SERVICE BULLETIN

APPLICABILITY: 2024MY Crosstrek

NUMBER: 12-264-26

SUBJECT: Front Fender Garnish Design Change

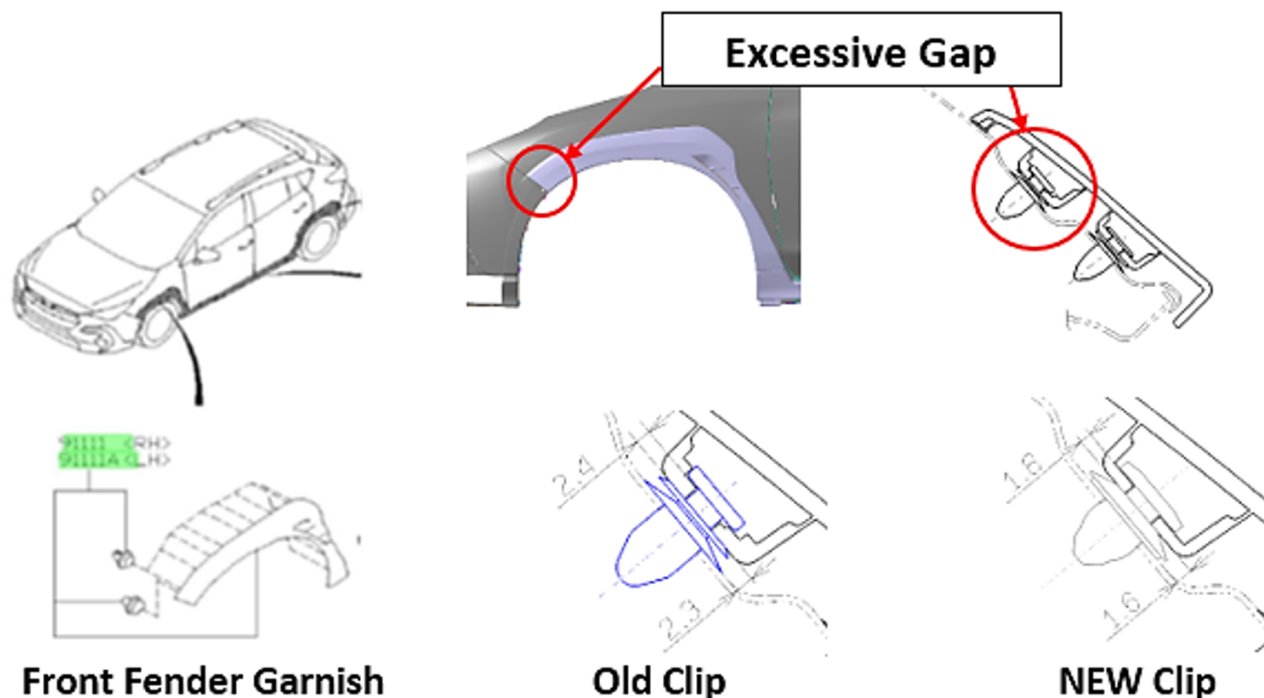
This bulletin announces the availability of new front fender garnishes fitted with new clips to provide a more secure and streamlined fit. If excessive gap between the fender and the fender garnish is reported by a customer, replace the affected garnish with the new part(s).

DESCRIPTION OF DESIGN CHANGE:

Part Description	Part Number
GARNISH-FRONT FENDER, RIGHT	91112FN001
GARNISH-FRONT FENDER, LEFT	91112FN21B
